Location of Construction: 10 Exchange Street		Owner: Joe Soley	Phone: 774-8300	Permit No: 000358
Owner Address: Joe Soley c/o Acres Real Est	Lessee/Buyer's Name: 388 Fore St. Portland, ME 04101	Phone:	Business Name: S/A	Permit Issued: APR 20 2000
Contractor Name: Joe Soley	Address: SAA	Phone: SAA		
Past Use: Retail	Proposed Use: Same	COST OF WORK: \$ 900.00	PERMIT FEE: \$ 30.00	Zone: CBL: 032-1-02
		FIRE DEPT. <input type="checkbox"/> Approved <input type="checkbox"/> Denied	INSPECTION: Use Group: M Type 3B BOCA 99 Signature: [Signature]	
Proposed Project Description: Insert stairs between 1st floor and basement. [basement to be used for storage only)		PEDESTRIAN ACTIVITIES DISTRICT (P.A.D.) Action: Approved <input type="checkbox"/> Approved with Conditions: <input type="checkbox"/> Denied <input type="checkbox"/>		Zoning Approval: Special Zone or Reviews: <input type="checkbox"/> Shoreland <input type="checkbox"/> Wetland <input type="checkbox"/> Flood Zone <input type="checkbox"/> Subdivision <input type="checkbox"/> Site Plan maj <input type="checkbox"/> minor <input type="checkbox"/> mm <input type="checkbox"/>

RE: 10 Exchange Street
CBL: 032-I-012
Permit # 000358

DATE: 7 APR

TO EXCHANGE ST.
INTERCOMMUNICATING STAIR

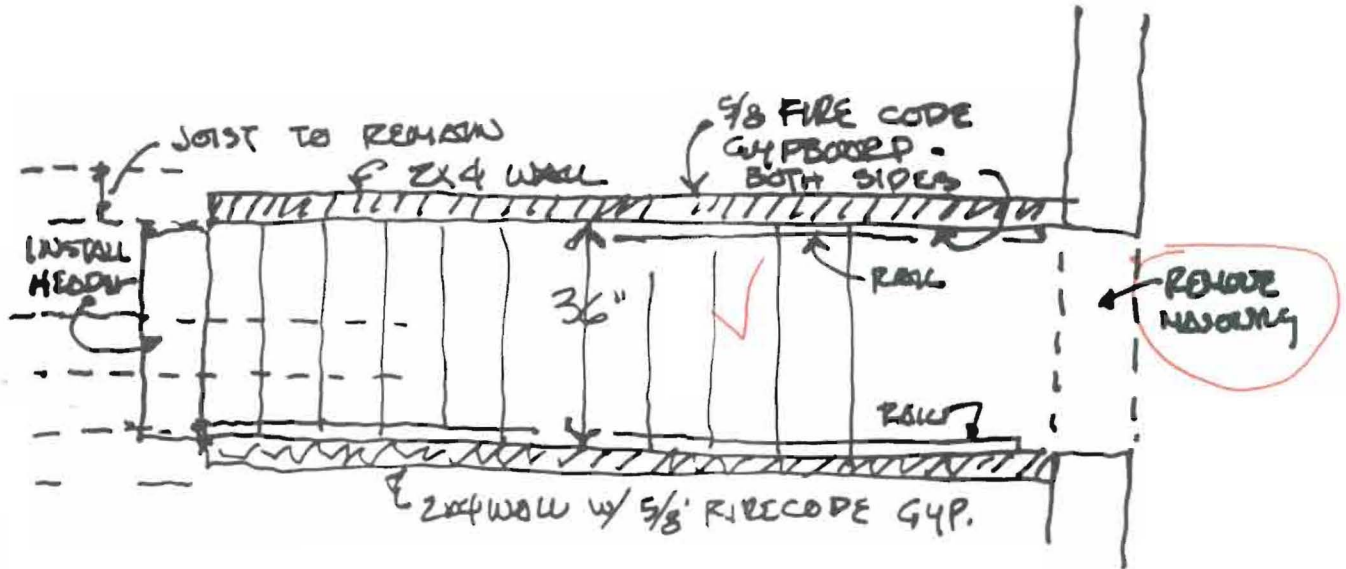
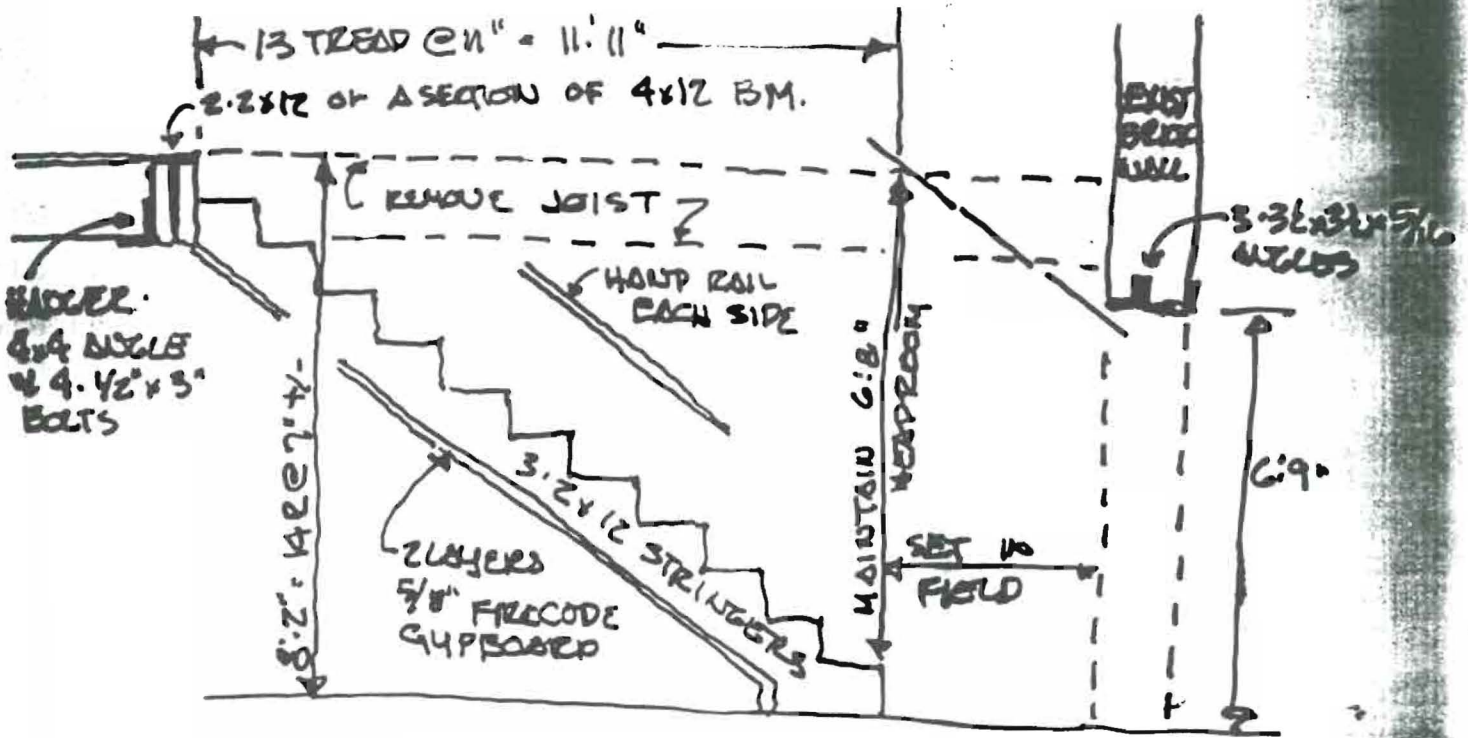
5-10-00 pre construction w/ Arthur - Mike I. & Joes. Reviewed stair detail 7" x 11" and the need for a structural analysis on brick wall. Also Fire Rated Separation of opening unless all exits are adequate in number and visibility/signage and per required codes. JB

6-1-00 Inspected stairs Rise/Run 7-11 except for top step which has 1/2" nosing and 1 1/4 measurement from ~~to~~ tread below. Headroom at step is 6' 2", need to correct to 6' 8", Handrail required on both sides returned.

6-8-00 Inspection w/ Steve W. Stair tread 1/4" ~~no~~ nosing, handrail unacceptable, Header unacceptable, fire Rating incomplete. JB Need to check on code for encroachment into required opening. JB

6-16-00 w/ Mike N. & Arthur, need to ~~bring~~ bring stair tread to code, 36" required opening, Stair handrail both sides consistent, less than 4" opening guardrails, inadequate headroom, need to see Lintel on stair side, need Engineer letter on Beam/Lintel junction on storage side, Landing at base of stair unsafe, Header at opening inadequate, Fire rate all - stop work order to meet requirements. JB

1. Section 1014.6.1 Beveling of nosing of stair treads shall not exceed 1/2 inch. See attached sheet.
2. Section 1014.4 Stairway headroom shall not be less than 80 inches.
3. Section 1014.3 Stairways shall not be less than 36 inches in width. 35+?
4. Section 1021.3 Balusters shall not be no further apart than 4 inches.
5. Section 707.1 and 1014.8.3 Stairway must be 1-hour fire rated. A 1-hour fire rated door must be at the top or bottom of the stairs.
6. Section 1014.7 Handrails shall be of an equal height and on both sides of the stairs.
7. Section 107.7 Steel beam/lintel in cellar at the foot of the stairs. Also unsupported beams in the cellar.

7-7-00 received letter from Nemco's
 8-22-00 w/ AR - stair width 35-35 1/2 varies, Head room ok, spacing ok, Guard Ht ok, Lintel viewed on both sides of header seem to be bearing on plywood wall partition, Nosing is still 1/4", NO Fire rated door. JB

9/12/2000 - conditions of letter of 6/20/00 have been met. Completed! A Rowe.

NFPA 101 sec.25-3.1 exception No. 1- " In Class A or Class B mercantile occupancies, unprotected openings shall be permitted between any two floors. ". This is part of the code, but the stairs do not need a fire rated door.

RE
10 EXCHANGE

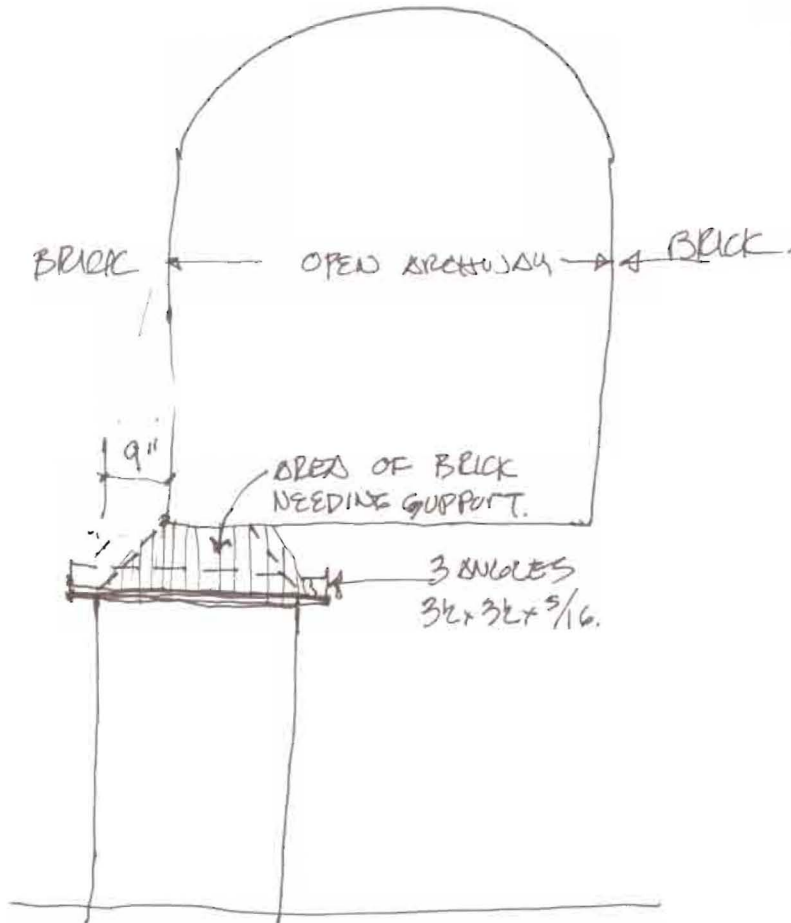
Inspected Angle irons for Lintel at brick opening - *Need to inspect header at joist cut for opening - no access today. Left message for Mike Tasha to call concerning code issues JB

This is a stop work order pursuant to Section 117.1 of the Building Code (BOCA 1999). All construction activity must stop immediately. You are required to file an engineer's report on the steel beam/lintel and the unsupported beams in the cellar. You are further required to submit adequate plans in order to comply with the requirements of items 1 through 6. You must comply by July 9, 2000. Failure to comply will result in this office referring the matter to the City of Portland's Corporation Counsel for legal action or possible civil penalties, as provided for in Section 1-15 of the Code and in Title 30-A M.R.S.A. ss4452. This constitutes an appealable decision pursuant to Section 121.5 of the Code. Please feel free to contact me at 874-8697 if you have any questions.

AS PER MY SKETCH OF APRIL 2/2000
AND AS PER NOTE # 21 ON THE BUILDING PERMIT
THE LITTLE OF 3 ANGLES OF 3/4" x 3/4" x 5/16" WILL BE
INSTALLED TO CARRY THE LOAD OF THE BRICK WALL
UNDER THE ARCH AS SHOWN ABOVE
